**STATE OF ILLINOIS
 DEPARTMENT OF TRANSPORTATION**

**LOCAL ROADS
 PROPOSED LIGHTING
 SCHEMATIC**

SCALE: NO SCALE	SHEET NO. 7 OF 10 SHEETS	STA. TO STA.
F.A.U. RTE. 5755	SECTION (81)-JM	CONTRACT NO. 64J68
	PROJECT ROCK ISLAND	217 115

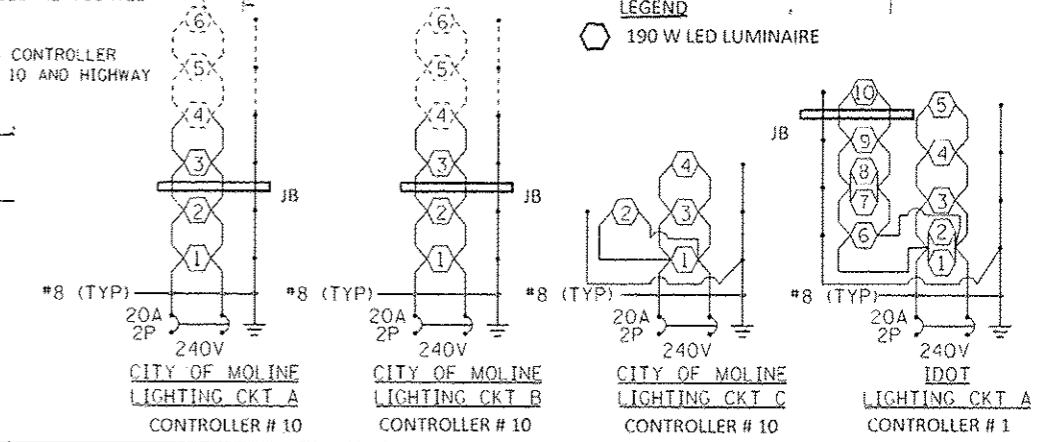
LIGHTING DESIGN WAS NOT SEND TO BDE FOR REVIEW. WE HAVE QUESTIONS WHETHER THE POLE LOCATIONS ARE ADEQUATE TO LIGHT THE ROADWAY. AGI DESIGN FILE FOR 19TH AND 23RD STREET INTERSECTIONS NEEDED TO SEE IF THESE INTERSECTIONS ARE PROPERLY LIGHTED
